CHANGE ORDER #44

CHILDREN'S HOSPITAL
OF ORANGE COUNTY

MISC. DETAILS

A11.8.1

A4 DAMAGE STUD REPAIR

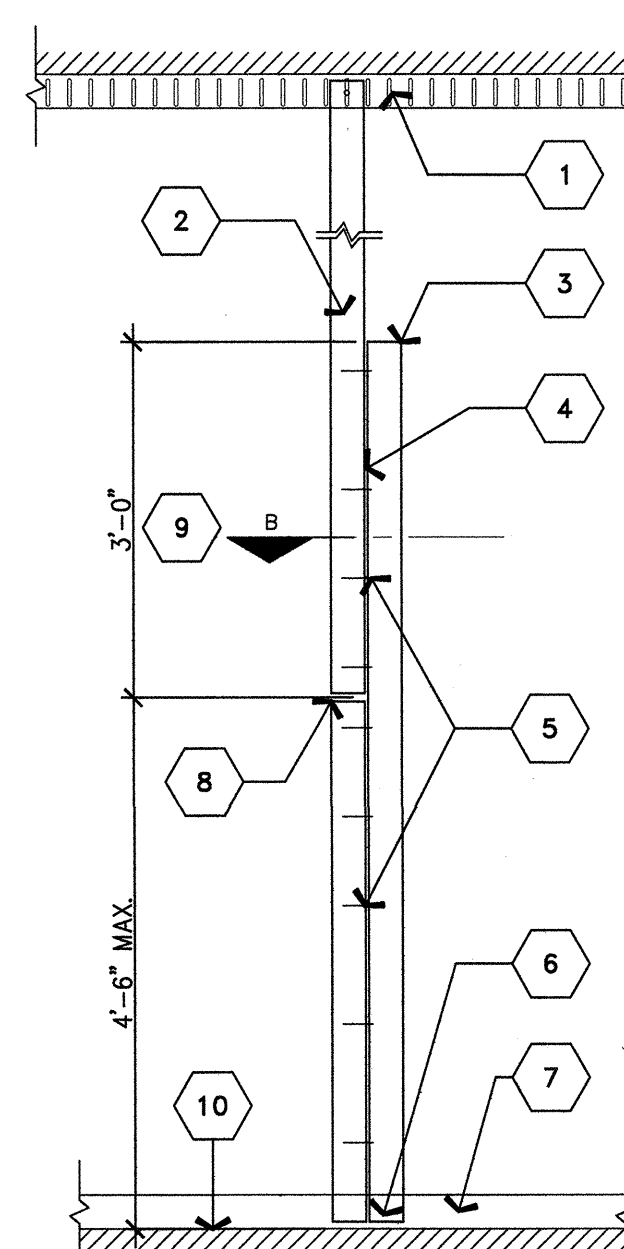
RFI 2010
Stud repair at outside corner

A2 STUD REINFORCING DETAIL

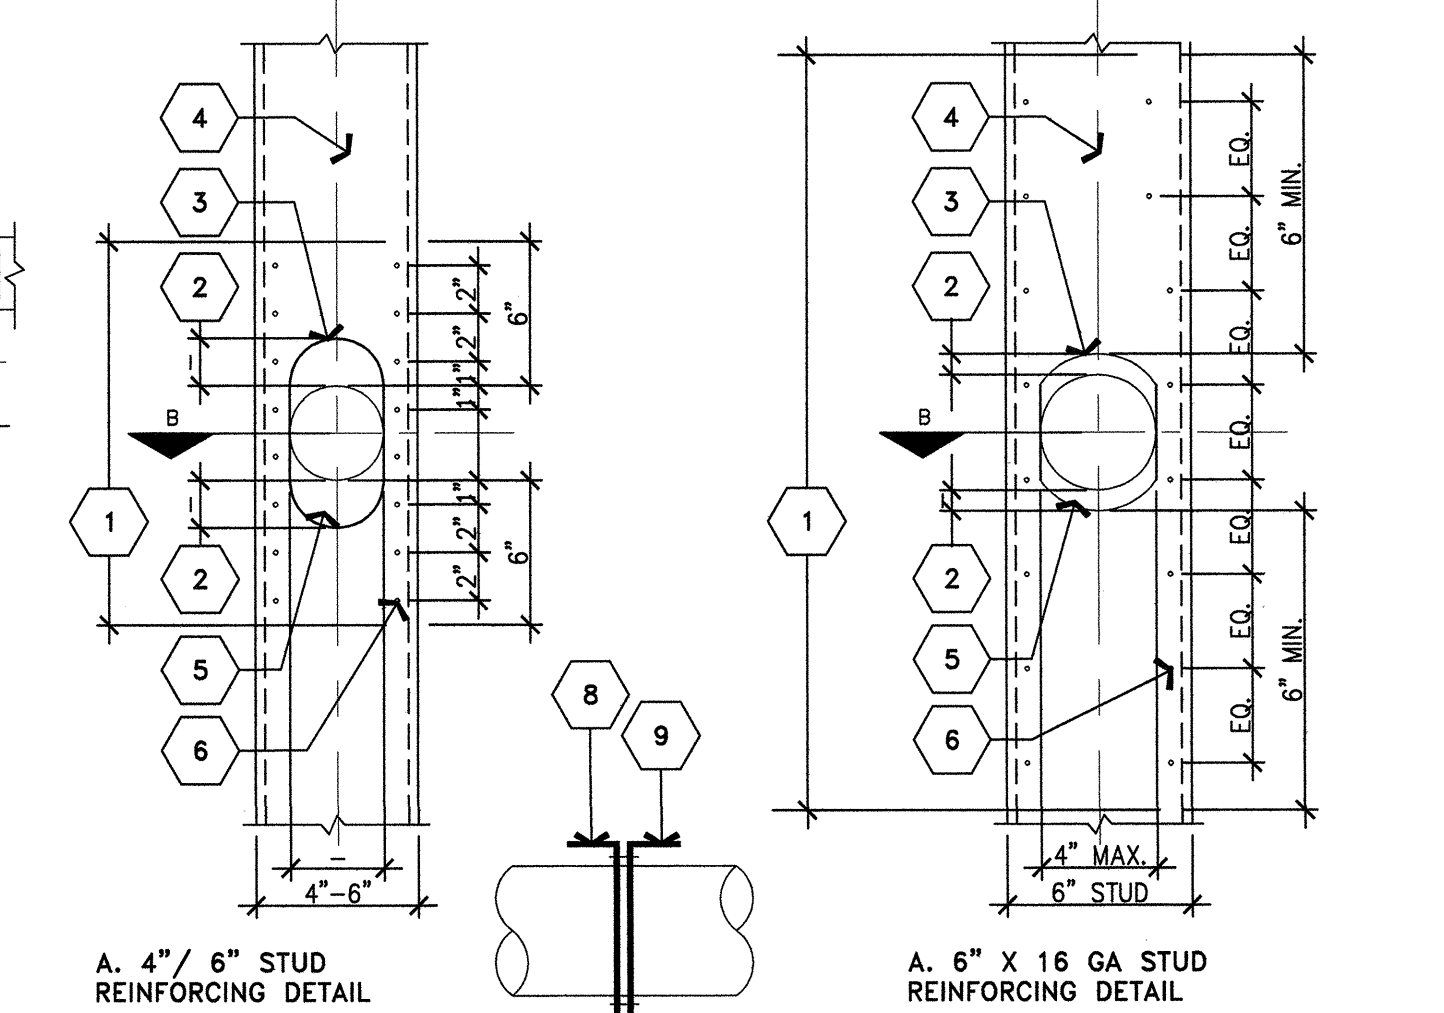
RFI 3108
Alternate stud
reinforcement for partition
intersections where studs
are not accessible

RFI 2660 Acceptable
to penetrate metal stud
per attached sketch
CK 879-1

NOTE:
1. FOR PIPE AND/ OR CONDUIT PENETRATIONS IN VERTICAL INTERIOR METAL STUDS 3" DIAMETER. REINFORCE THE STUD PER THE PROJECT SPECIFICATIONS.
